Subject: Transmittal of Class 1 Permit Modification to Update Figures in the Los Alamos National Laboratory (LANL) Hazardous Waste Facility Permit, EPA ID No. NM0890010515

CLASS 1 PERMIT MODIFICATION NOTIFICATION STRUCTURE CHANGES AT TECHNICAL AREA 54

ENV-DO-14-0023

LAUR-13-29257

Figure 9: Technical Area (TA) 54 West Location Map Showing Security Fences, Entry Gates, and Entry Stations

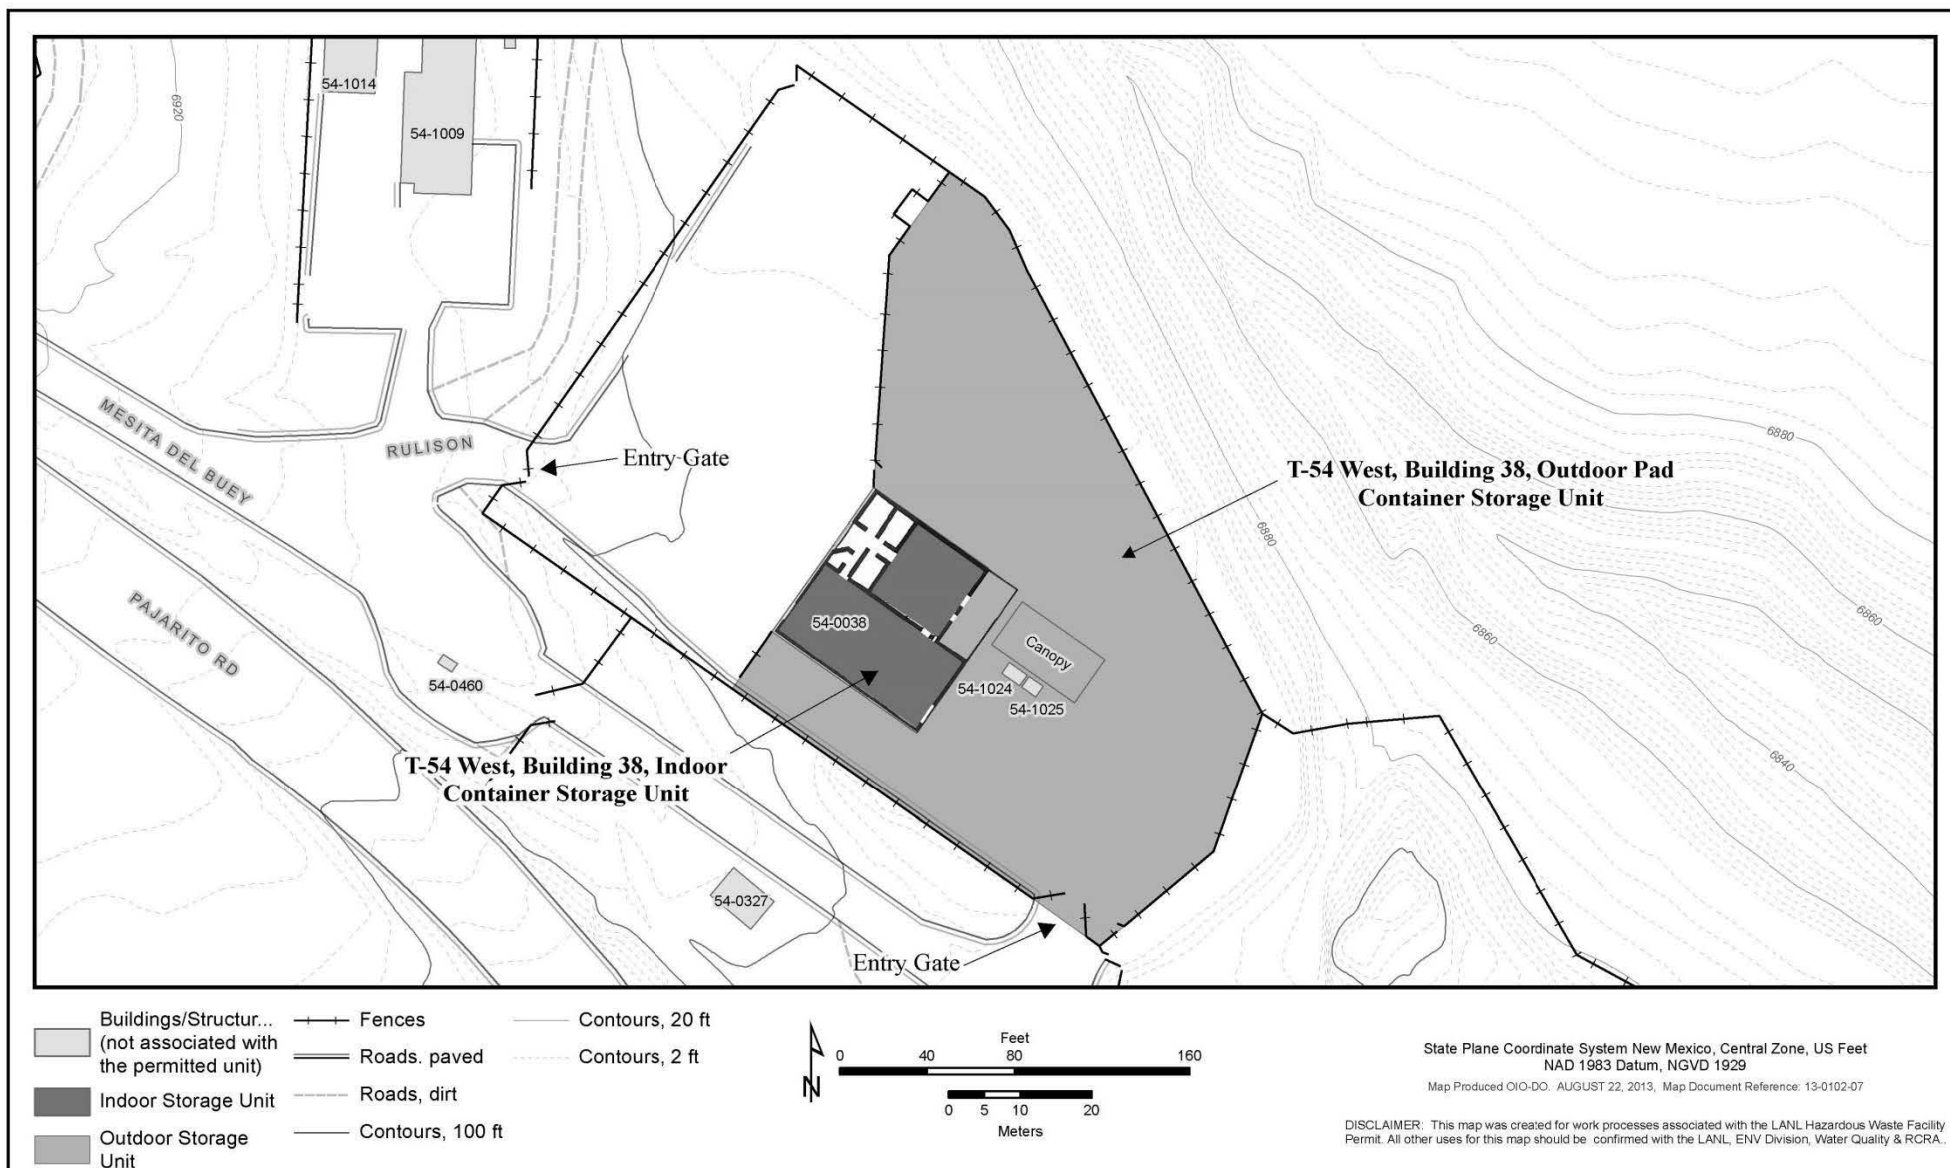
Figure 9 (Technical Area (TA) 54 West Location Map Showing Security Fences, Entry Gates and Entry Stations) and Figure 37 (Technical Area (TA) 54 West, Building 38 Indoor (High Bay and Low Bay) and Outdoor Pad) were revised to remove Structure 54-34 and to make the fence line continuous. Structure 54-34 previously served as part of the fence line boundary for the permitted unit. The structure was removed and the fence around the unit was completed to demarcate the boundary of the permitted unit.
